Errata for the  
PCI Express Base Specification, Revision 1.1

Updated Feb 2007

***Errata for the PCI Express Base Specification, Revision 1.1***

Figure 5-15-4: Link Power Management State Flow Diagram

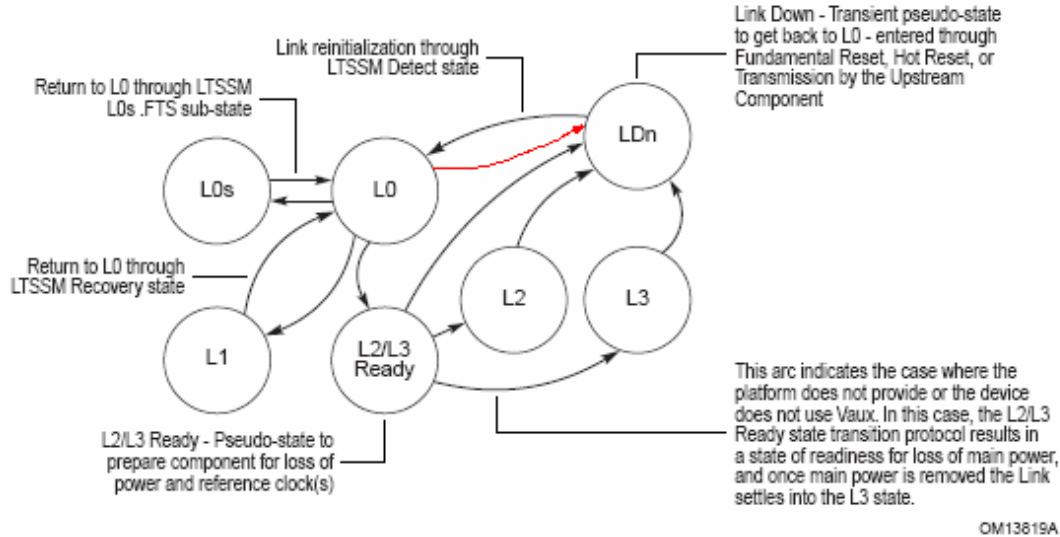
*Add an arc to Fig 5-1:*

590 IN ADDITION TO ARC ADDED IN THE FIGURE ABOVE change the upper right hand text in the figure as shown here:
